Item 3
Variance Request
SAB 2/19/13

A **Variance Request** by Daniel Woods on behalf of The Addison Group to vary the Streamside Buffer for Waters of the State serving less than one (1) square mile of tributary area from sixty (60) feet to thirty (30) feet along Sharps Branch for the property located at 1319 West Main Street.

Streamside Buffer Variance Request (1319 West Main St)

Staff Report and Analysis

Figure 1: 1319 West Main St – Parcel Boundary (highlighted in pink)

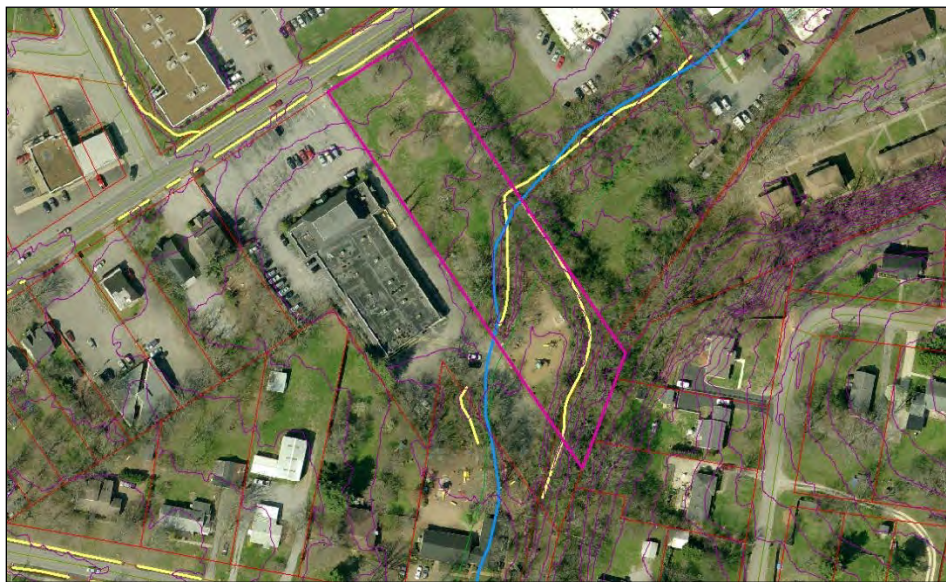
1. In regard to the first standard, the difficulty illustrated by the applicant is due to the intensity at which the applicant wishes to develop this property. Alternative designs are available to reduce amount of area needed to provide parking for a multi-family building, such as providing parking structures or parking underneath the building. Furthermore, the wet-weather conveyance appears to be a relic channel of Sharps Branch, based on historical USGS maps and an evaluation of existing contours which suggest the stream now flows along the property line instead of through the middle of the property (Fig 2).

3. As far as the third standard is concerned, the appellant notes in the request letter that hardship would result from applying the required sixty (60) feet Streamside Buffer because of the unique linear shape of the property and how Sharps Branch traverses the property in an atypical manner. Accepting the hypothesis that Sharps Branch was relocated from the center of the property to flow along the property line, this relocation increased the amount of

buildable area for the property at 1319 West Main St and reduced the difficulty that would have been rendered by complying with Streamside Buffer Requirements of the *Stormwater Management Ordinance*. Therefore, coupled staff's opinion of the first and second standards, staff believes the applicant's situation is not unnecessarily burdensome, and therefore does not meet third standard as set forth in the *Stormwater Management Ordinance*.
